Tri-City Medical Center

TCMC Parking Structure and Main Entry

06/26/2018

ADDENDUM #3

L-5

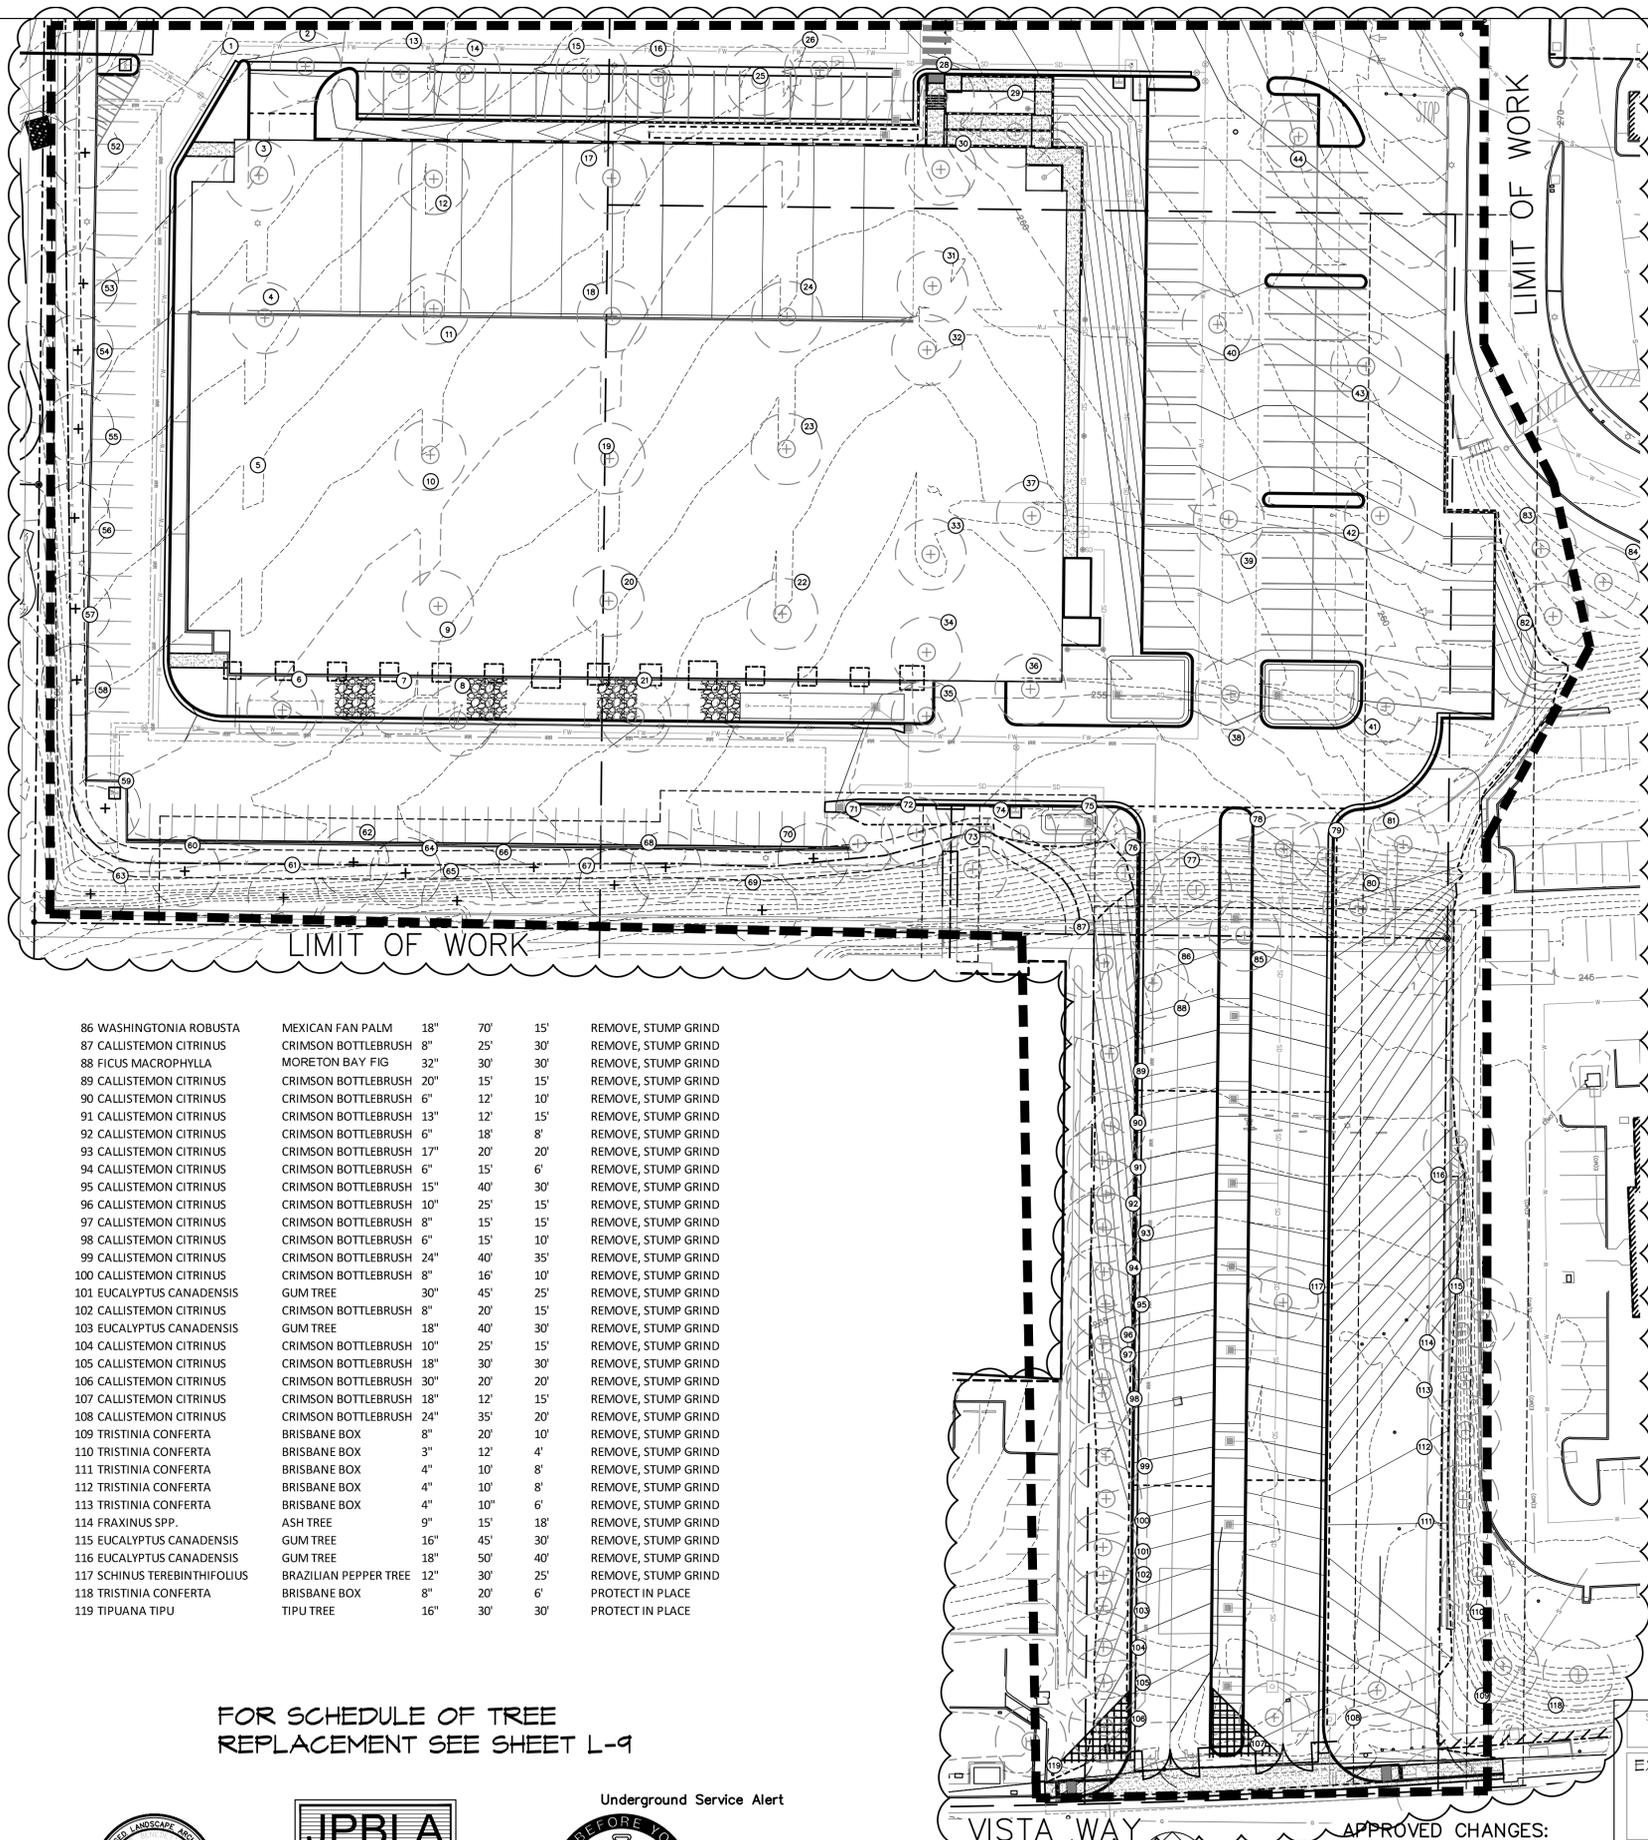
NO.	DESCRIPTION	APP'VD	DATE
1	EX TREE NO.S ADDED - JPBLA		6.25.18
